**PRE-FILED TESTIMONY  
OF  
JASON BRANNICK**

**PETITION OF APPALACHIAN POWER COMPANY  
FOR APPROVAL OF ITS 2025 RPS PLAN UNDER  
§ 56-585.5 OF THE CODE OF VIRGINIA AND RELATED REQUESTS**

**CASE NO. PUR-2025-00049**

**PREFILED TESTIMONY  
OF  
TANNER S. KATSARELIS**

## Staff Screening of Wythe BESS

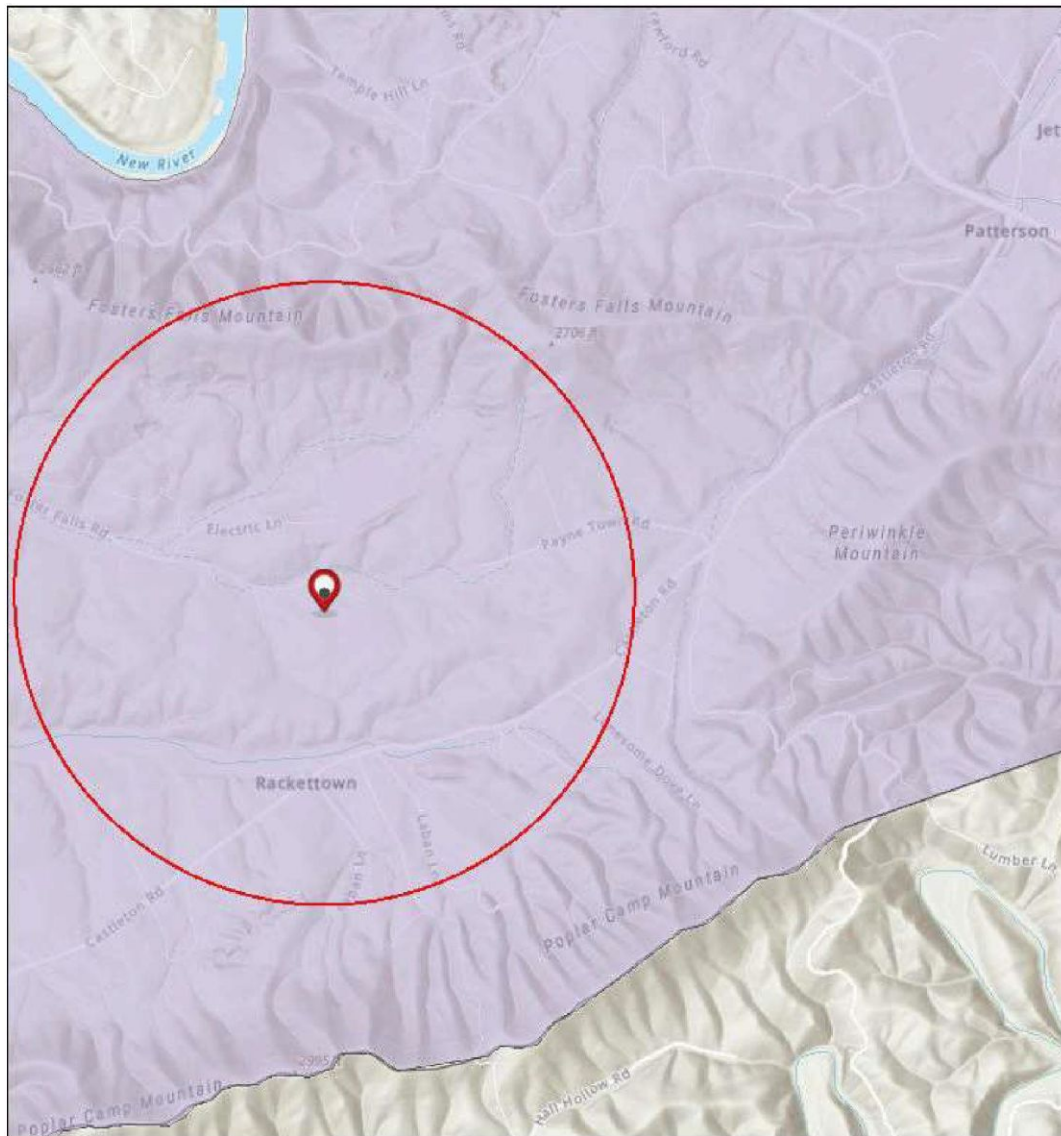
**A.** Yes. Staff performed an EJ screening report for the HCE Collier Solar PPA facility and the proposed Company-owned Wythe BESS facility, using the Virginia Department of Environmental Quality's EJScreen+ tool. The results were consistent with the Company's screening reports for both facilities. Specifically, Staff's analysis identified two census block groups as low-income EJ communities for the proposed HCE Collier Solar PPA facility, while one census block group was identified as a low-income EJ community for the proposed Wythe BESS facility.<sup>30</sup> These results match the results of the Company's analysis.<sup>31</sup> As such, Staff does not oppose the Company's EJ analysis and screening reports in the instant case.
